**Re: California Independent System Operator Corporation
Docket Nos. ER12-2207-000 and ER12-2209-000**

**Southern California Edison Company
Docket Nos. ER12-2206-000 and ER12-2208-000**

Response to August 10, 2012 Commission Staff Letter

**ISO Response to August 10, 2012 Request for Additional Information
Docket Nos. ER12-2207, ER12-2209, ER12-2206, ER12-2208**

Figure 1 – Schematic Outlining Interconnection Facilities Under Dispute

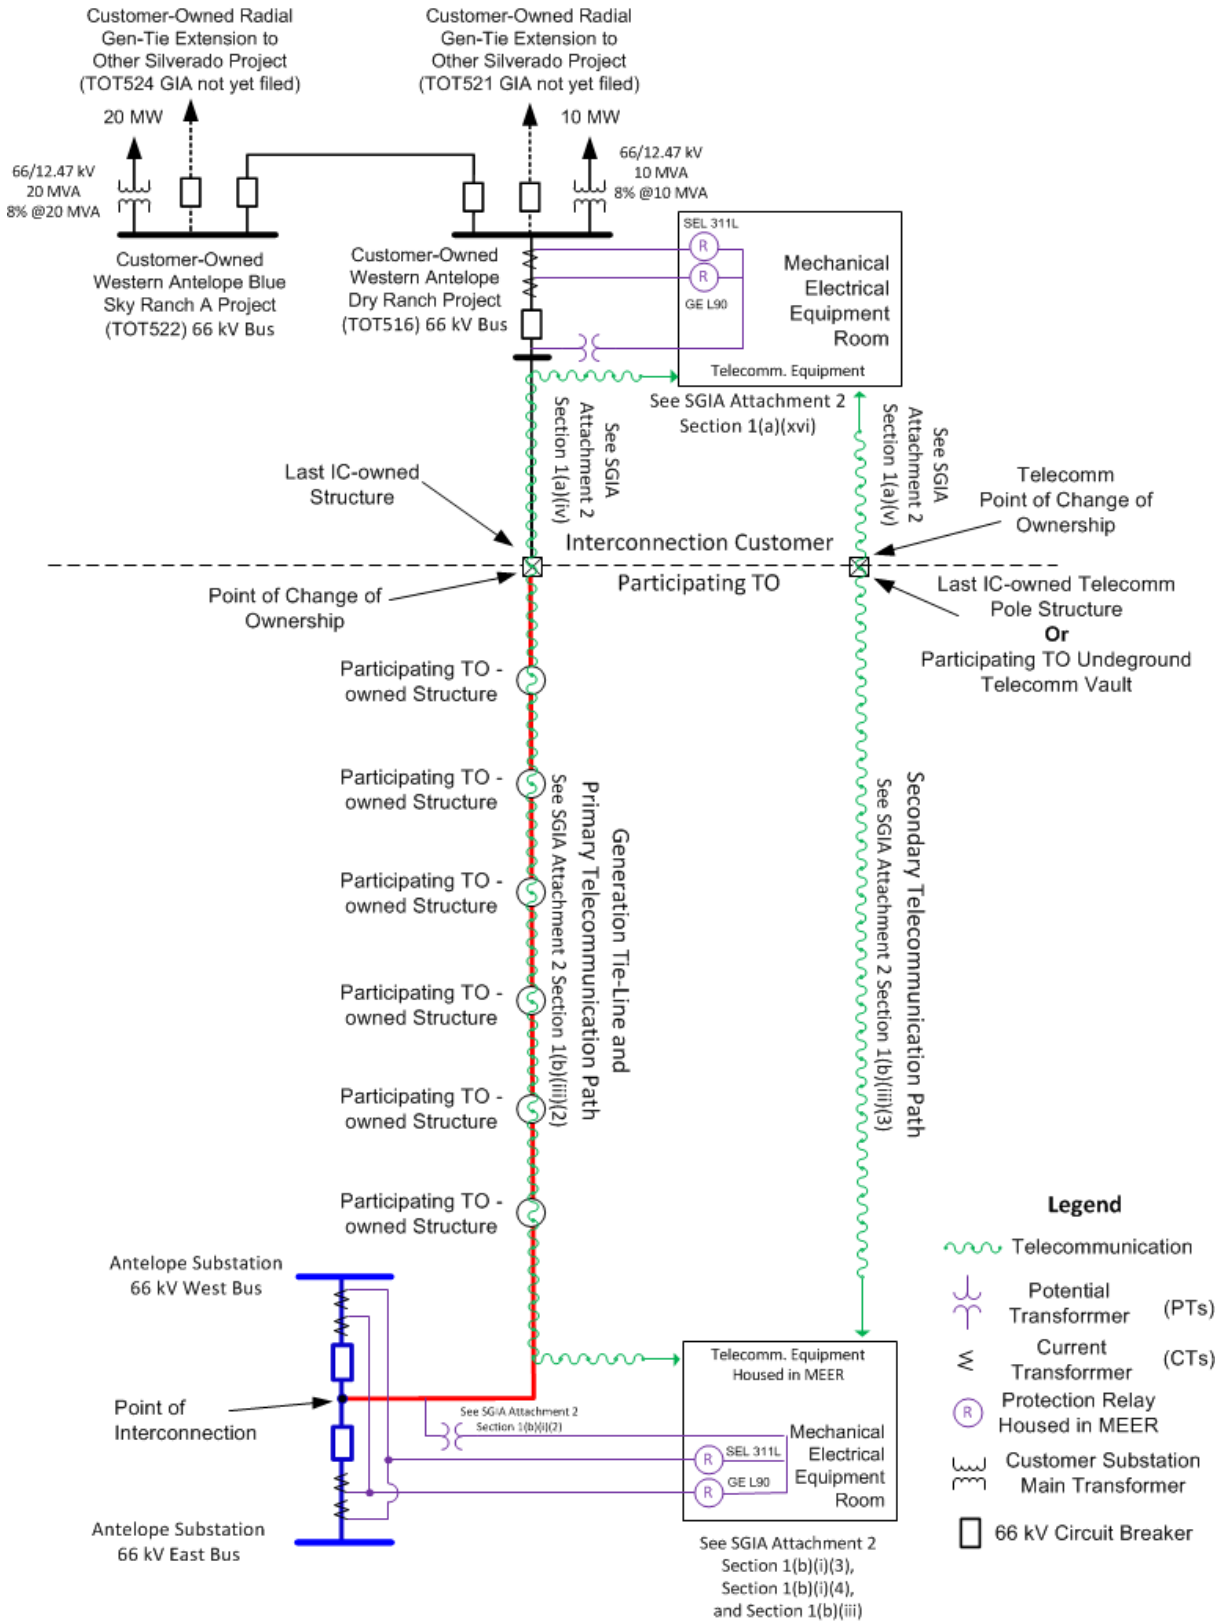
a. *Provide a detailed schematic showing the proposed location of the fiber optic cables and associated protection equipment relative to the point of interconnection for each of the project's facilities (identified in Attachment 3 of each SGIA).*

- b. *Provide a protection system diagram showing the fiber optic cables and associated protection equipment as part of the entire protection system and coordination scheme as designed by SoCal Edison/CAISO for each project, and/or any other purpose.*

- a. Provide a detailed schematic showing the location of the relays relative to the point of interconnection (identified in Attachment 3 of the SGIA).*

- a. *Provide a detailed schematic showing location of the relays and telecommunication equipment relative to the point of interconnection (identified in Attachment 3 of the SGIA).*

SCE has provided a schematic with its responses entitled “Figure 1—Schematic Outlining Interconnection Facilities under Dispute” in its September 7, 2012 response, which is an annotated version of Attachment 3 to the SGIA's. SCE's annotations on the Figure 1 schematic show the proposed locations of the facilities described in SGIA Attachment 2, Section 1(a)(iv) and (v). For convenience, the ISO has also included the Figure 1 schematic as the last page of these responses.

The ISO has reviewed the Figure 1 schematic and description and believes it to be correct and thus has no additional response to provide.

Response: The Figure 1 schematic, which SCE has attached to its responses, depicts the protection system. The ISO agrees with SCE that the purpose of these fiber optic cables and telecommunication facilities is to (i) provide adequate coordinated protection to the generation tie-line and (ii) support the generator's remote terminal unit (RTU).

Response: The Figure 1 schematic in SCE's responses shows the location of the relays below a box that identifies the Mechanical Electric Equipment Room.

The GE L90 and SEL 311L relays that are depicted on the Figure 1 schematic are not sufficient to support a future special protection scheme; in the event that an SPS were needed in the future, additional relays would have to be added, such as GE N60 relays, which SCE identifies in its response to this question .

Response: The requested detail is provided in the Figure 1 schematic.

Figure 1 – Schematic Outlining Interconnection Facilities Under Dispute

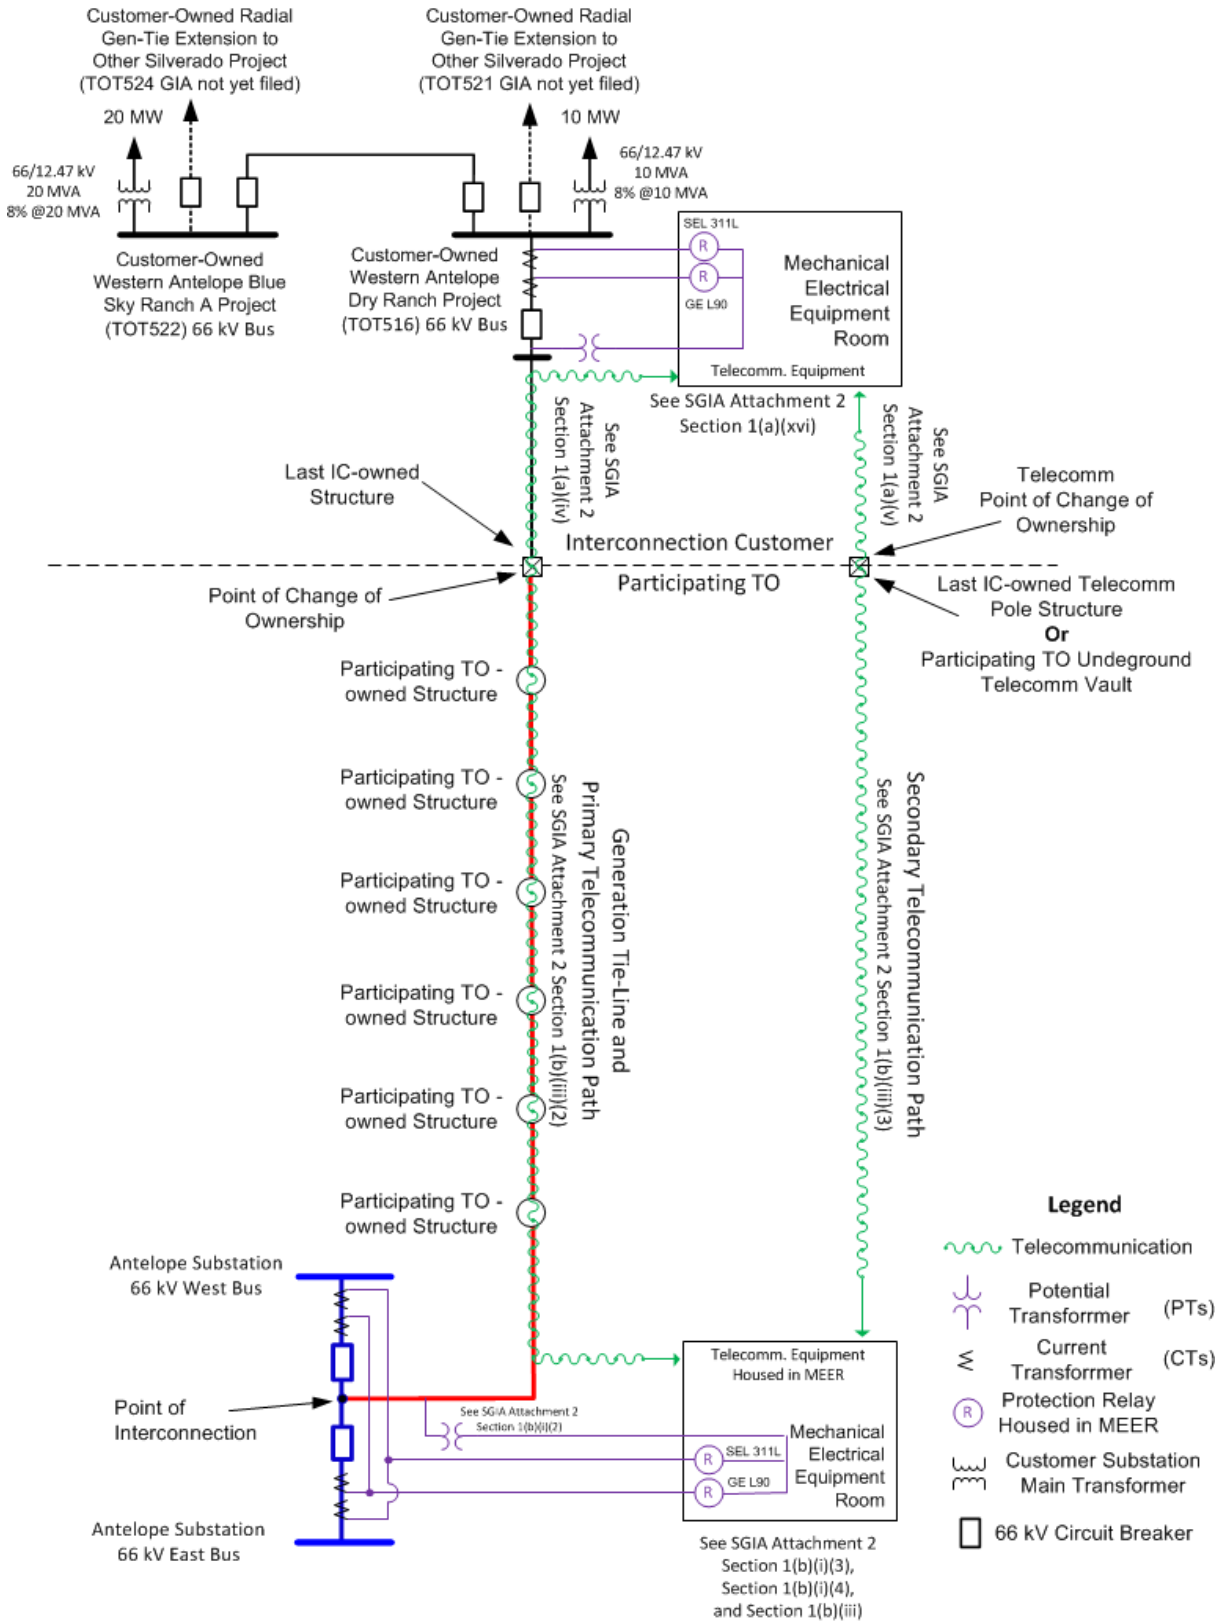
- a. Provide a detailed schematic showing the proposed location of the fiber optic cables and associated protection equipment relative to the point of interconnection for each of the project's facilities (identified in Attachment 3 of each SGIA).

- b. Provide a protection system diagram showing the fiber optic cables and associated protection equipment as part of the entire protection system and coordination scheme as designed by SoCal Edison/CAISO for each project, and/or any other purpose.

- a. Provide a detailed schematic showing the location of the relays relative to the point of interconnection (identified in Attachment 3 of the SGIA).

- a. Provide a detailed schematic showing location of the relays and telecommunication equipment relative to the point of interconnection (identified in Attachment 3 of the SGIA).

Response: Please refer to the attached Figure 1. SCE has annotated Attachment 3 to the SGIAs, filed in FERC Docket Nos. ER12-2206 and ER12-2208, to show the location of the fiber optic cables and associated protection equipment relative to the interconnection facilities for these projects. The facilities at the generation site consist of customer-owned SEL 311L and GE L90 relay protection installed at the customer-owned substation Mechanical Electrical Equipment Room (MEER), customer-owned fiber cable, diversely routed customer-owned fiber cable, and SCE-owned telecommunication equipment located at the Generation Facility site that is used to couple and decouple signals on the fiber cables. The facilities at the Antelope Substation consist of SCE-owned SEL 311L and GE L90 relay protection installed in the existing common MEER building, SCE-owned fiber cable, diversely routed SCE-owned fiber cable, and SCE telecommunication equipment located at the Antelope Substation that is used to couple and decouple signals on the fiber cables.

Response: Please refer to the attached Figure 1. The sole purpose of these fiber optic cables and telecommunication facilities is to provide adequate coordinated protection to the generation tie-line and support the generator's Remote Terminal Unit (RTU).

Response: Please refer to Figure 1.

Response: Please refer to Figure 1.
